BID PACKAGE 02 – ADDENDUM 01**Date:** January 10, 2020**Re:** Wilma P Mankiller Health Center Expansion**From:** James R Childers Architect, Inc.
45 South 4th Street
Fort Smith, Arkansas 72901

CHANGE NARRATIVE LETTER

TO: MATHEW THOMAS- CHILDERS ARCHITECTS
FROM: STEPHEN EDMONDSON, TREY SMITH, BETSY WELLS– HP ENGINEERING, INC.
DATE: 1/10/2020
PROJECT: WPMHC EXPANSION BID PACKAGE 02 ADDENDUM 01

SHEET NUMBER:
E2.11
NORTH SECTOR 1 LEVEL 02 ENLARGED LIGHTING PLAN

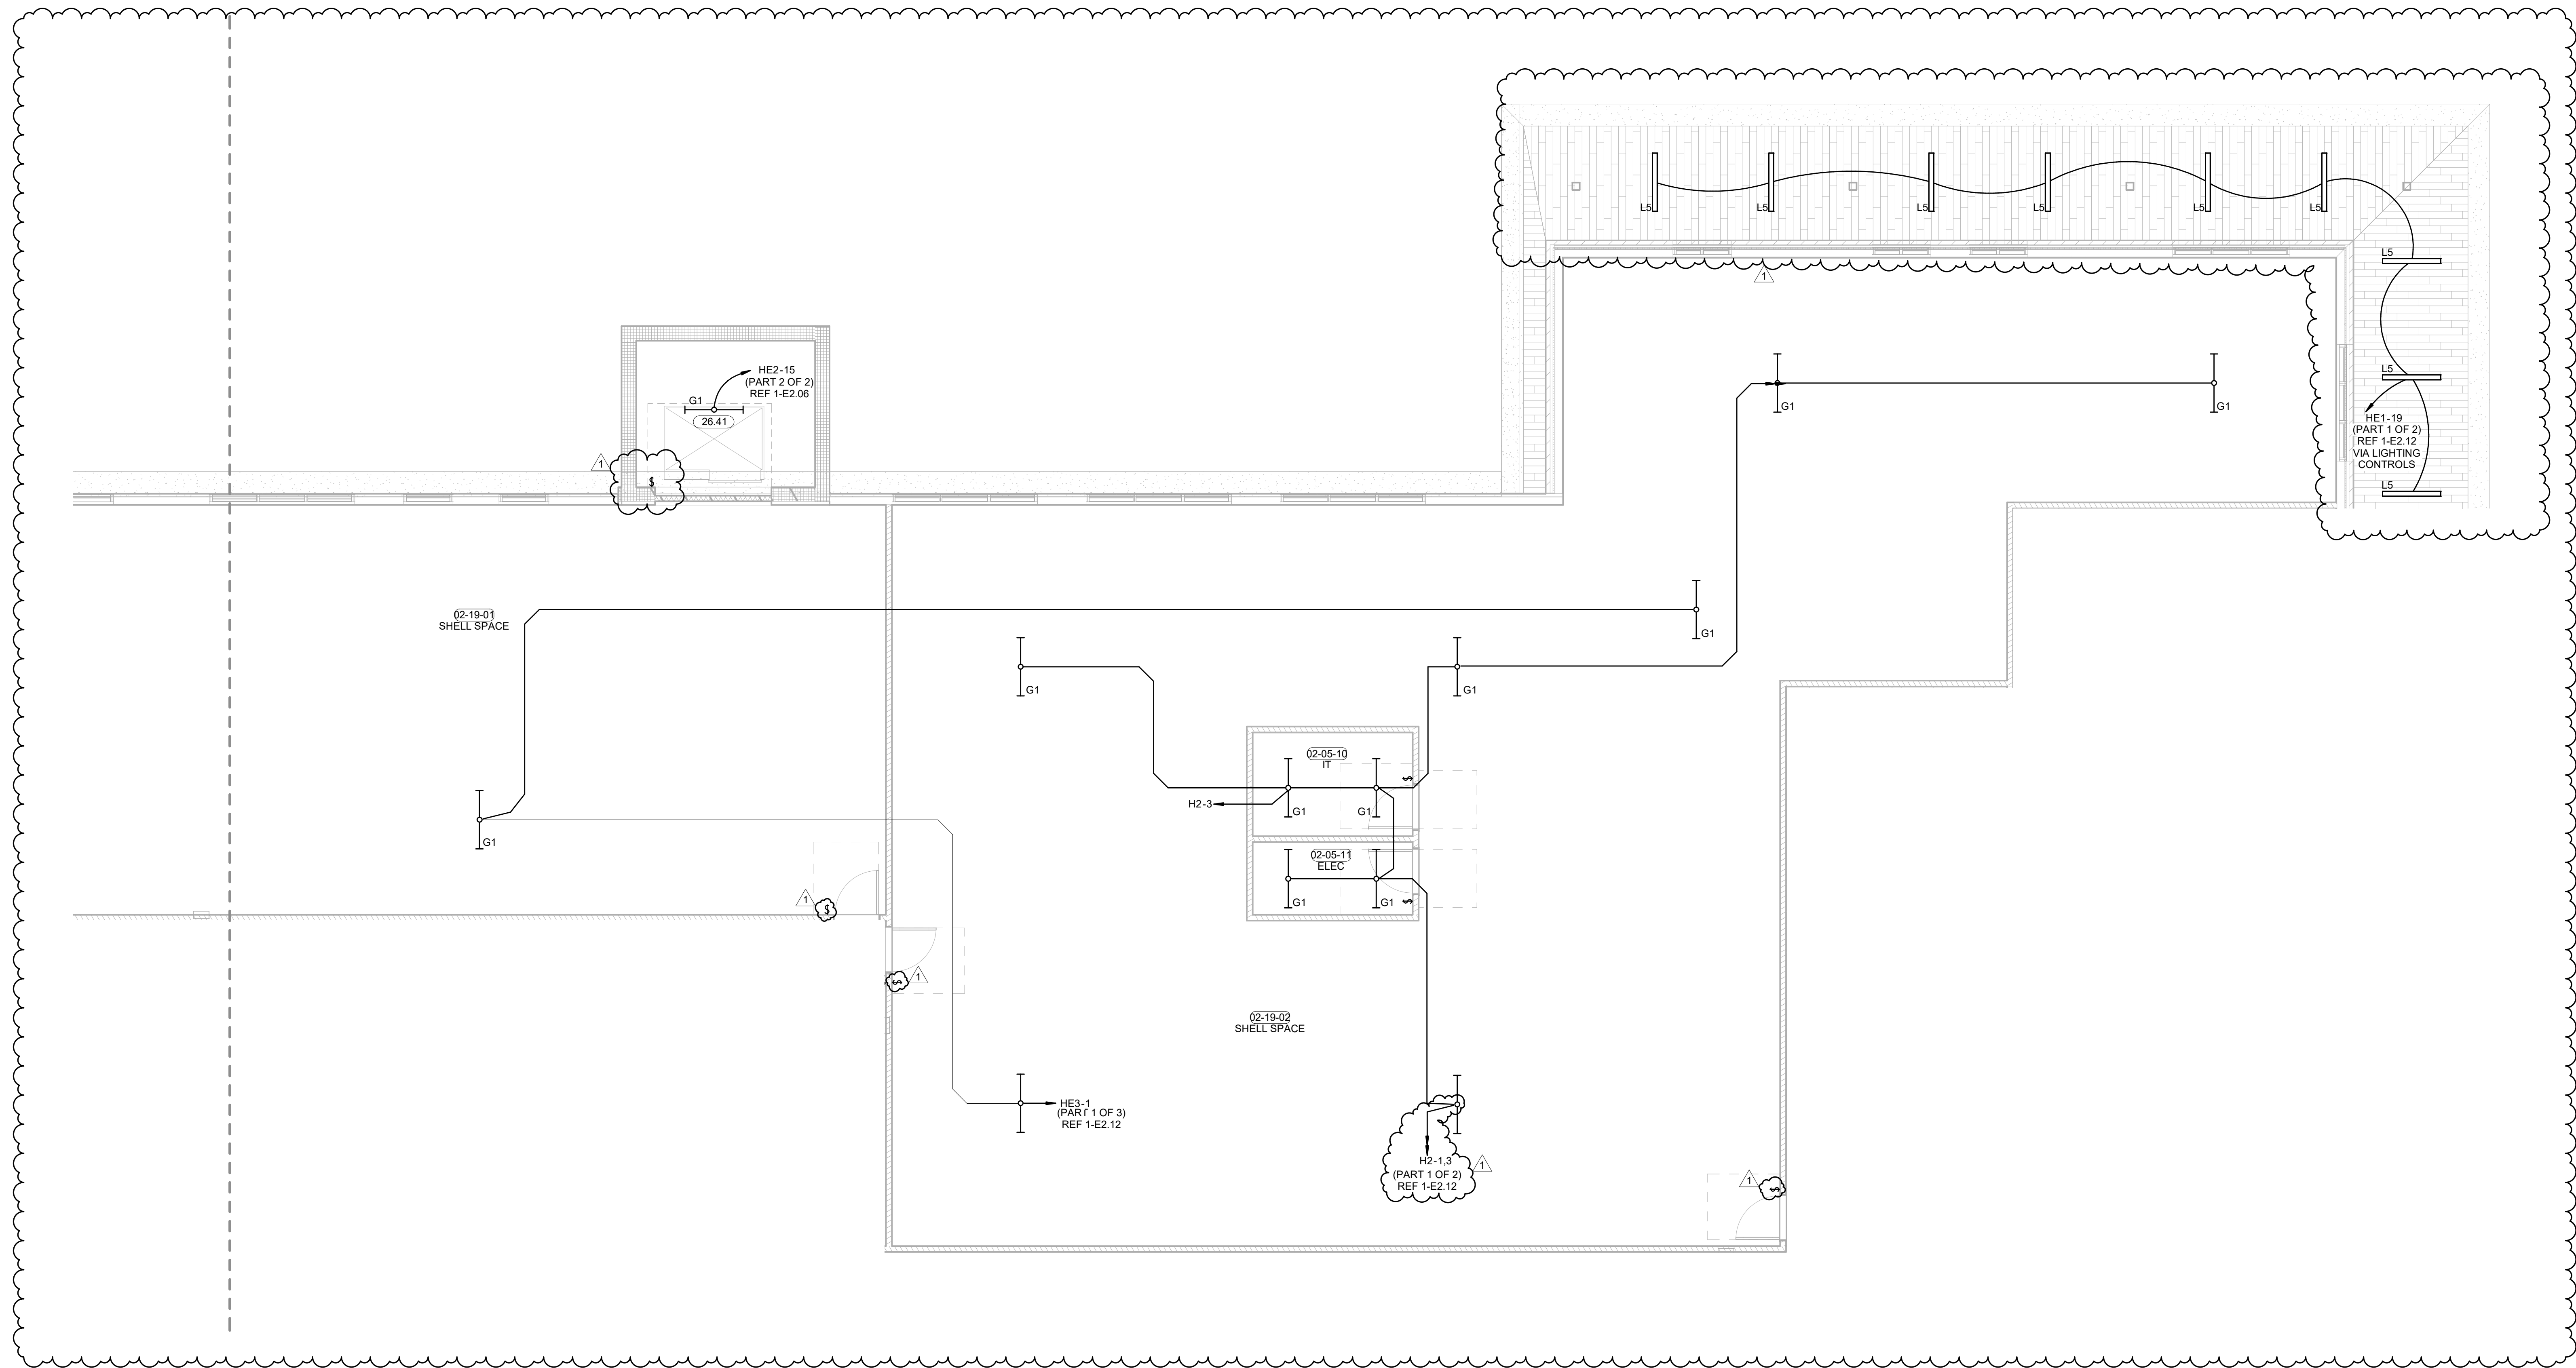
31. E2.11
- a. Detail 1 – Added circuitry note for circuit HE3-1.
 - b. Detail 1 – Added (1) switch to Shell Space 02-19-01.
 - c. Detail 1 – Added (2) switches to Shell Space 02-19-02.

SHEET NUMBER:
E2.12
SOUTH SECTOR
1 LEVEL 02
ENLARGED
LIGHTING PLAN

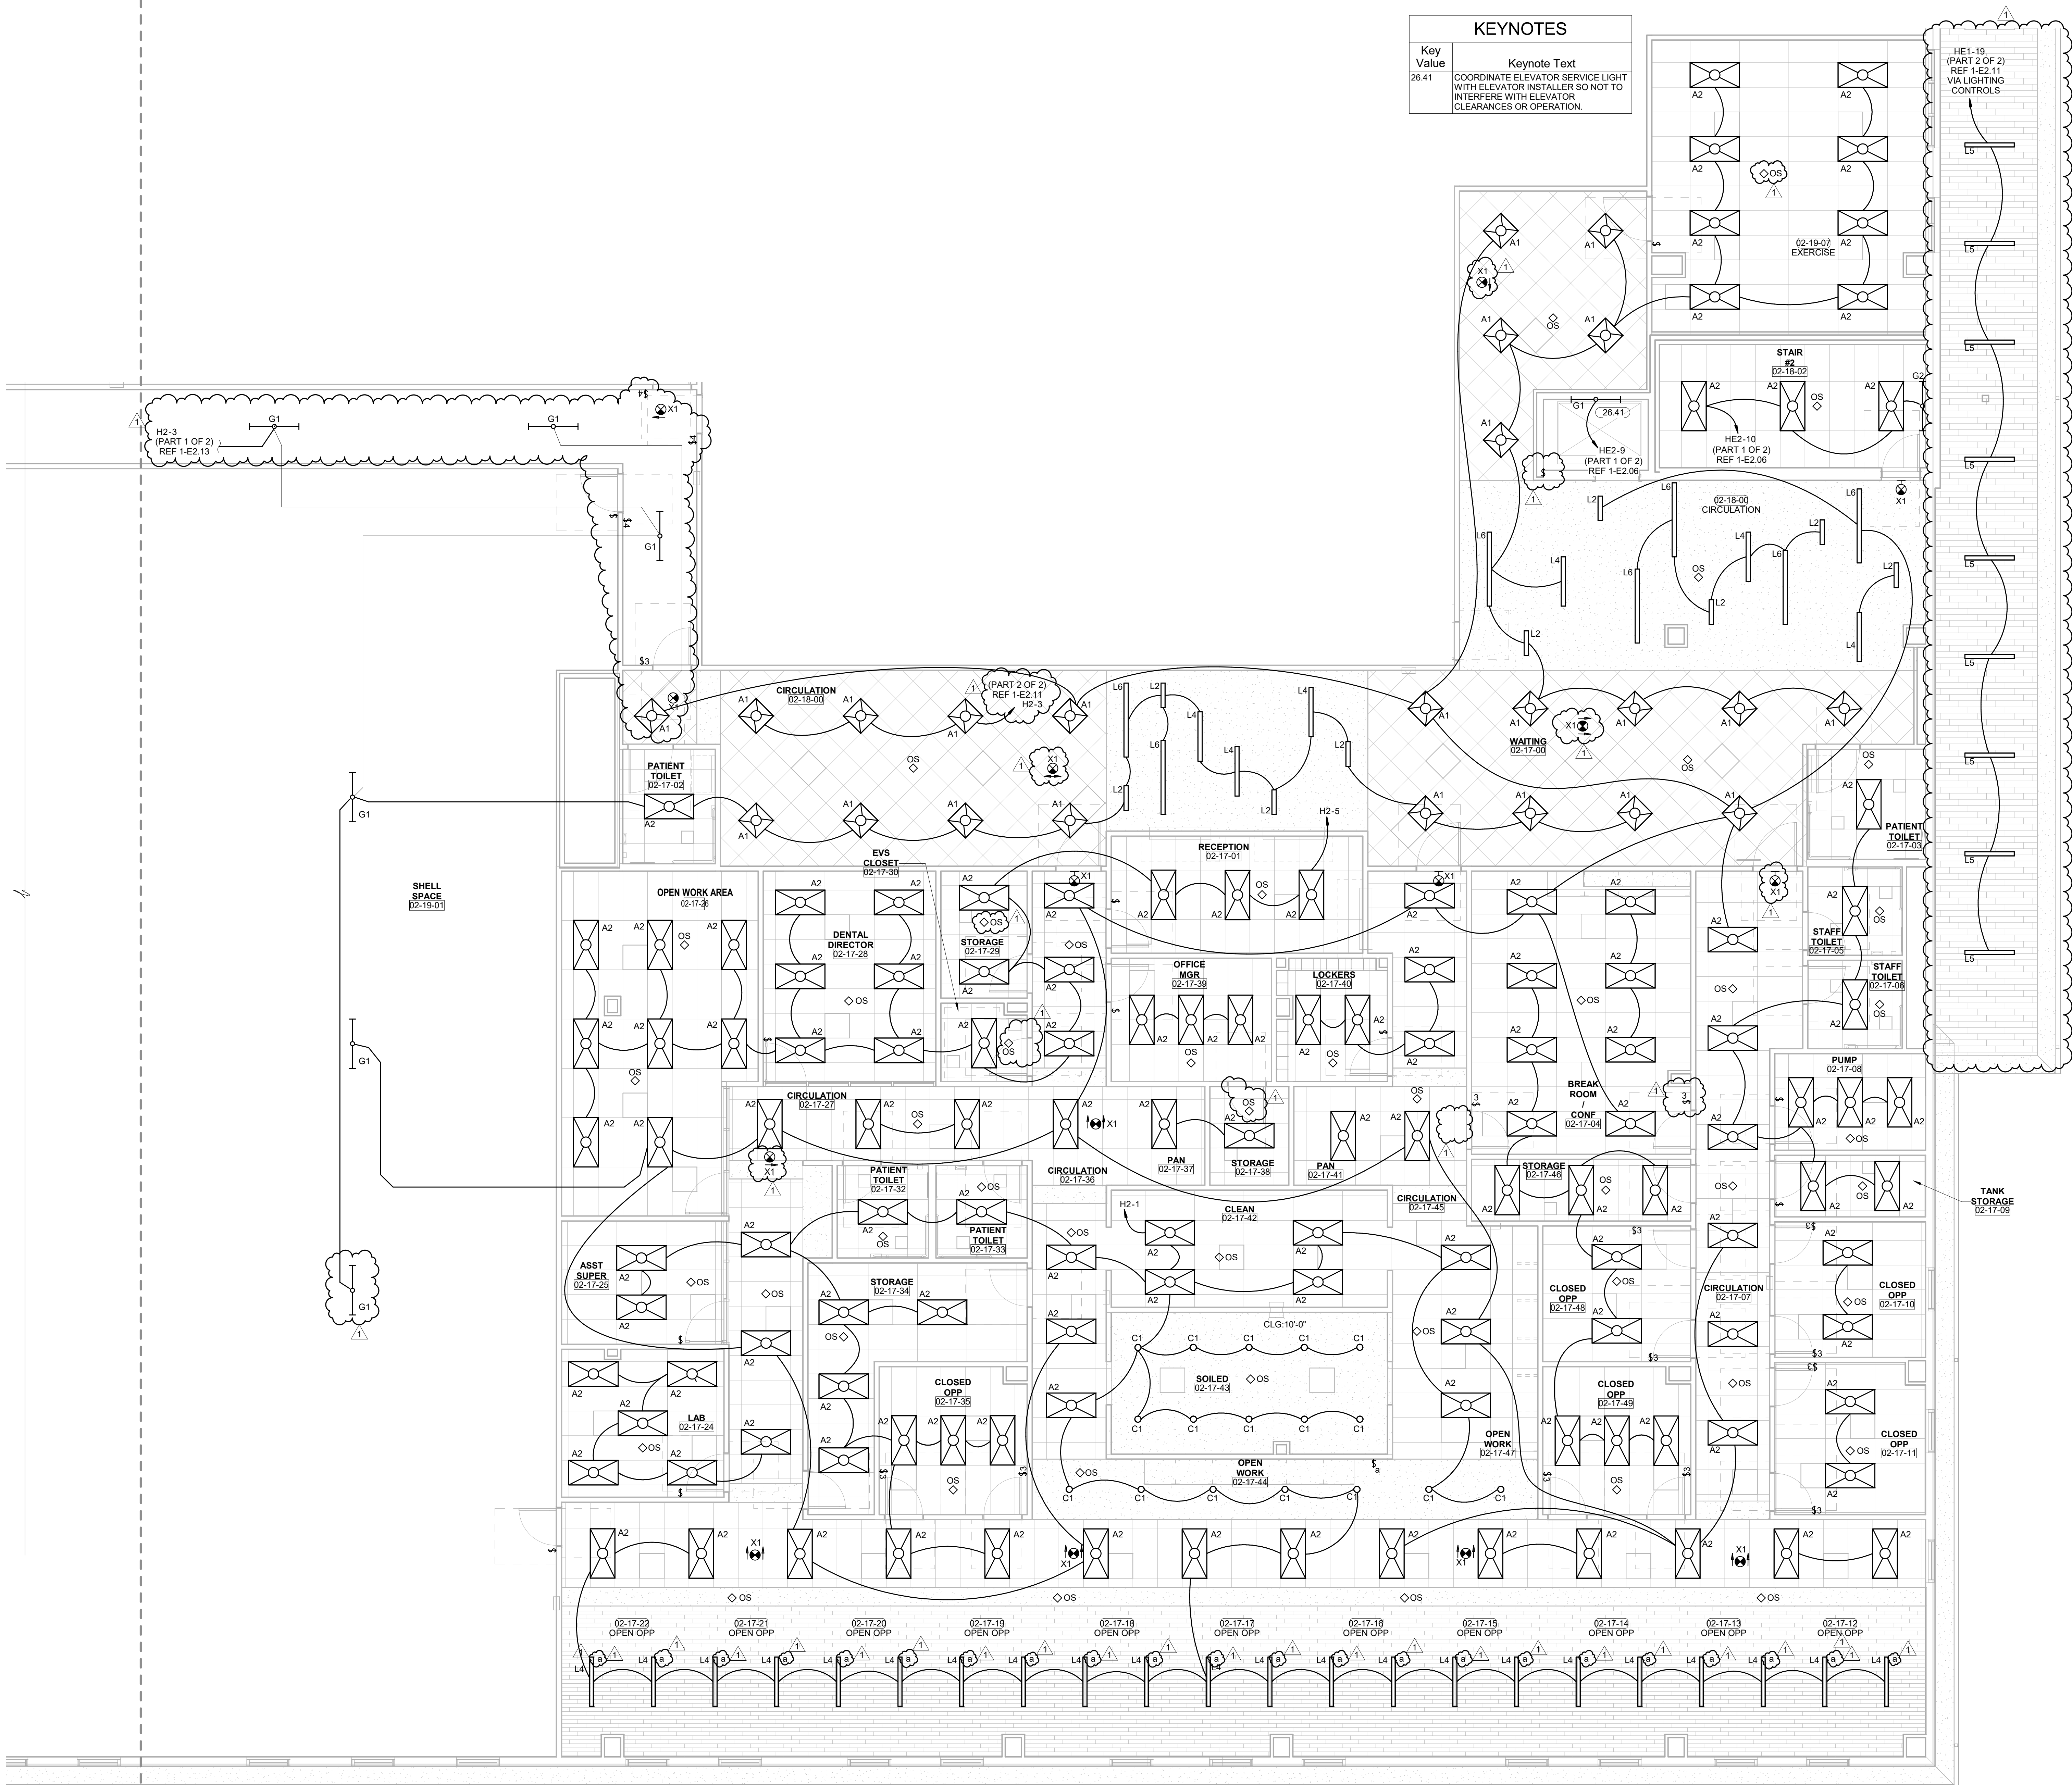
32. E2.12
- a. Detail 1 – Added (11) switches for Open Opp areas.
 - b. Detail 1 – Added (1) Type G1 fixture to Shell Space 02-19-01.
 - c. Detail 1 - Added (1) Type X1 fixture to Circulation 02-17-27.

- d. Detail 1 – Removed wall OS from EVS Closet 02-17-30.
- e. Detail 1 – Added (1) ceiling OS to EVS Closet 02-17-30.
- f. Detail 1 - Added (1) ceiling OS to Storage 02-17-29.
- g. Detail 1 – Removed wall OS from Storage 02-17-38.
- h. Detail 1 – Added (1) ceiling OS to Storage 02-17-38.
- i. Detail 1 – Removed (1) Type X1 fixture from Circulation 02-17-45.
- j. Detail 1 – Revised (1) Type X1 fixture to be wall mounted in Circulation 02-17-07.
- k. Detail 1 – Added (1) Type X1 fixture to Waiting 02-17-00.
- l. Detail 1 – Revised (1) Type X1 fixture to be single faced in Circulation 02-18-00.
- m. Detail 1 – Hallway ceiling has been removed. Hallway fixtures changed to G1 fixture
